REF:: DRAINAGE REPORT FOR GLYN GILES APARTMENTS (J-20 D-17)
RECEIVED JULY 16, 1984.

J20-D17
3rd Submittal
DRAINAGE REPORT

RE: Glynn Giles Apartments Drainage Plan (J20-D17)

DRAINAGE REPORT
Glyn Giles Apartments
J-20

HYDROGRAPHS - AREAS DRAINING TO STORM SEWER

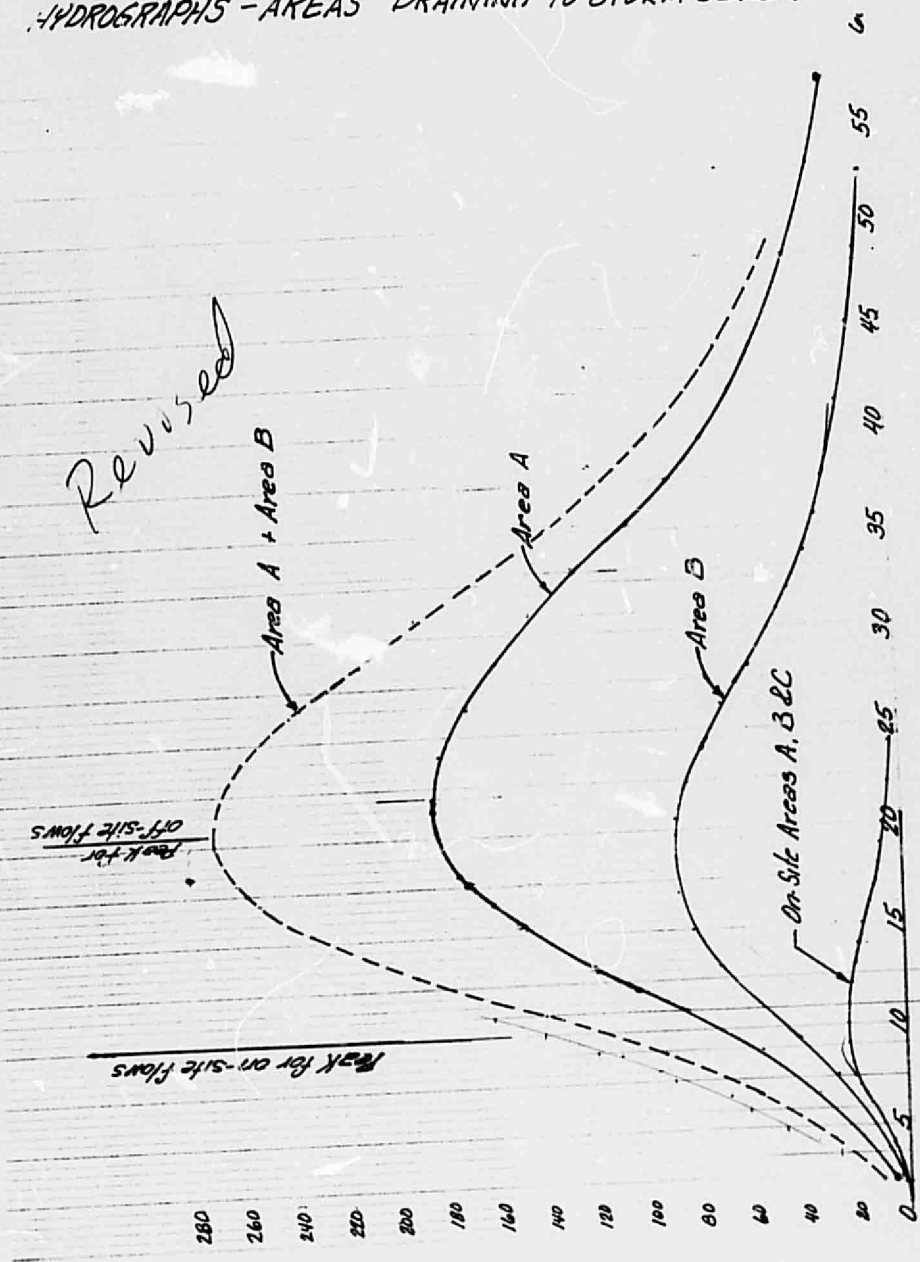
- a. Show that the storm drain can handle the flows or that the flows from your site will sufficiently "beat the peak" and that these flows can be conveyed to the ultimate discharge point without aggravating any existing problem.

- a. ✓ Hydrographs have been prepared which show that the discharge from the site "beats the peak" of the hydrograph for the areas served by the storm sewer.

1. The proposed site is the last remaining undeveloped parcel in the drainage area which flows to the storm sewer in Sellers Drive
2. The hydrographs on page 7 shows that the peak for on-site flows which enter the storm drain occur about 10.5 minutes ahead of the peak for the off-site flows which come from as far away as the intersection of Florieta Street and Constitution Avenue. Therefore, free discharge of site drainage will not cause the capacity of the storm sewer to be exceeded.
3. There are no downstream flood hazard zones. The flood hazard zone on Jaffa Road has a different outfall than the outfall for this report, i.e., the two 60" pipes which discharge into the I-40 channel. The total discharge from this site will not cause the capacity of these pipes to be exceeded as shown in section IV.
